November 5, 2012

Subject: **Comment Letter - Chevron #9-0329 Case Closure Summary**, Revised Notice of Opportunity for Public Comment; Underground Storage Tank Cleanup Fund Case Closure Recommendation; Claim Number 6001; Fuel Leak Case No. RO0000269; Global ID # T0600101885; Chevron #9-0329, 340 Highland Avenue, Piedmont, CA 94611

Summary of ACEH's Review of the USTCF's UST Case Closure Summary

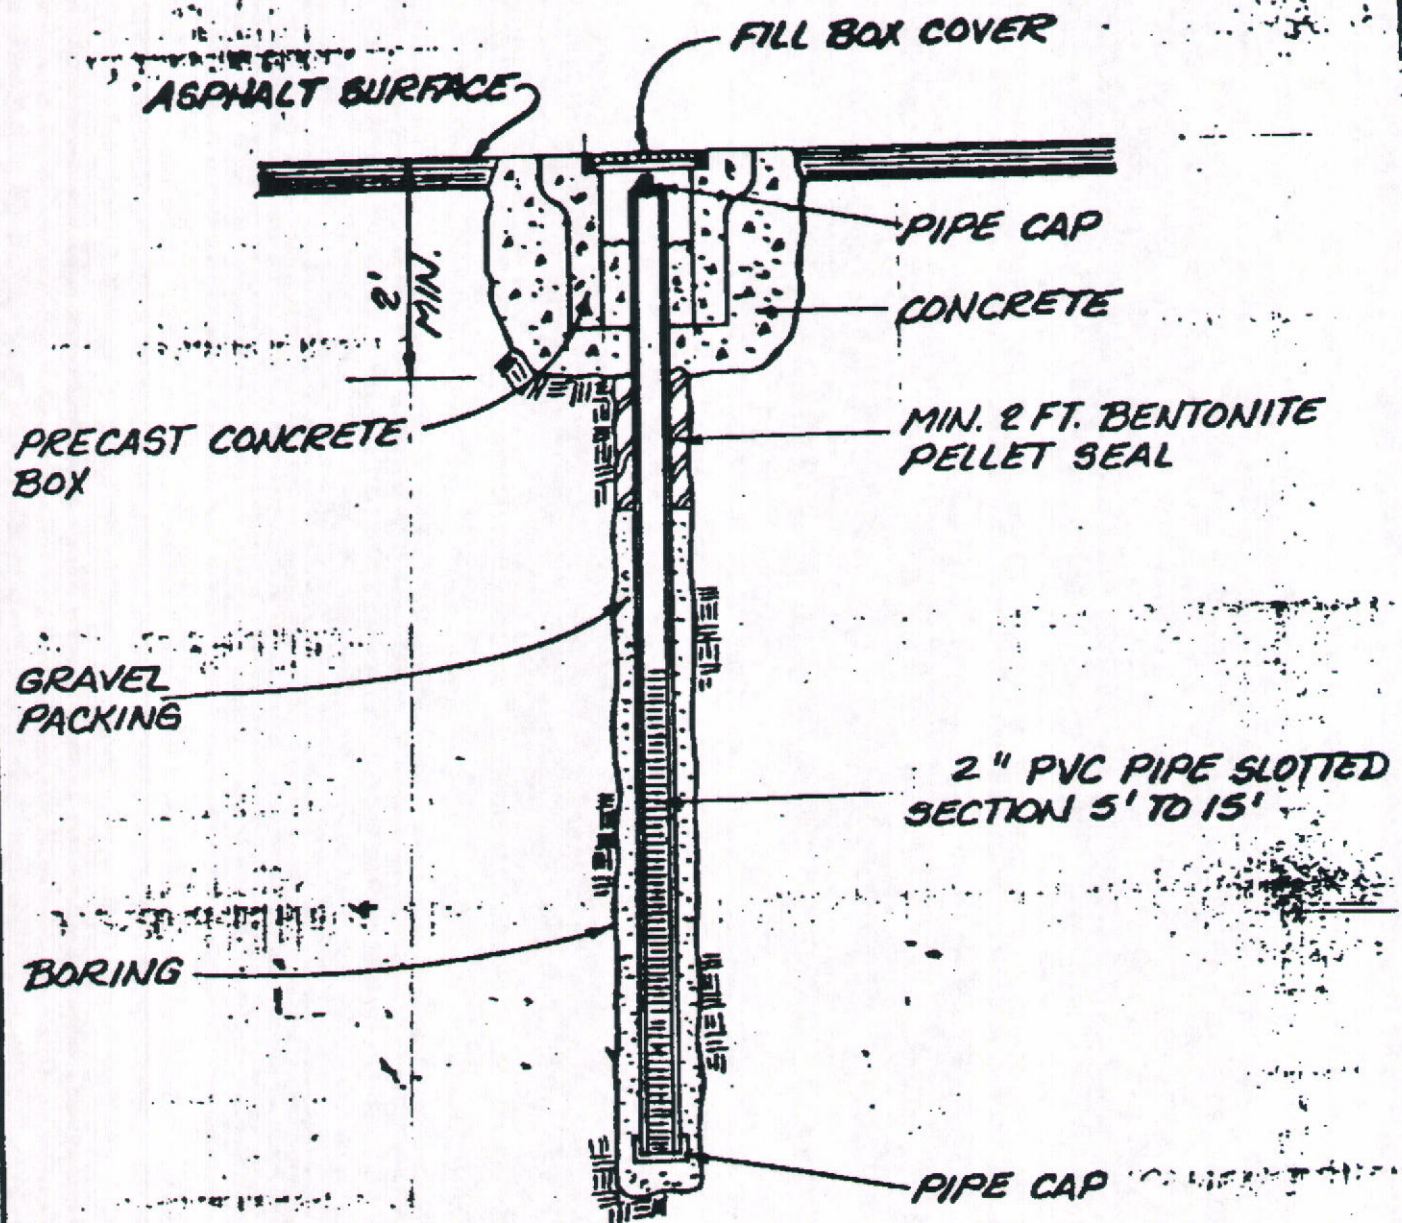
LNAPL was reported at a thickness of ¾-inch (0.06 feet) at the time of development of well C-2. However, as onsite wells appear to be submerged by between 4 to nearly 7 feet (see discussion in General Criteria e), potentially up to 7 feet of product may have been present at that date, and not been detected. Analytical data indicates that contaminant concentrations are on a declining trend at the site; however, technical literature, including that cited in the SWRCB’s CA LUFT Manual, suggest that submerged wells do not produce representative groundwater concentrations or determine the thickness of LNAPL.

- Identification of and discussion of well conditions. As discussed above, submerged wells are incapable of collecting representative groundwater or LNAPL thickness measurements. Data documenting submerged conditions in wells at the site did not become available until February 2008, and thus this condition was not evaluated in the 2003 CSM and 2006 CSM update. Available generic (non-specific) well construction details indicate wells C-1 to C-4 were installed to depths of 15 feet below ground surface (bgs), with well screens installed between 5 and 15 feet bgs; however, field well depth measurements indicate these wells were installed to 17 feet bgs, thus the screen may be installed between 7 to 17 feet bgs, (implied by selection of a standard screen section length). Although no well construction details are available for wells C-1, C-2, and C-3. Given that depth to water at the site ranges from 0.25_ to 1.4 feet bgs, the site wells may consequently be submerged 6 to 7 feet. The exception to these apparently submerged water-table wells, is well MW-6 which was artesian shortly after installation and was therefore decommissioned; no other site wells have been artesian. The November 16, 2006 Cambria CSM update report states that there appears to be no hydraulic connection between well MW-6 and other site wells. This further suggests that well C-2 acts more as a submerged water-table well. Well C-2 is also currently measured to be 11.12 feet in depth and therefore contains up to approximately 6 feet of sediment. See Attachments 2, 3, and 4 for well construction details.
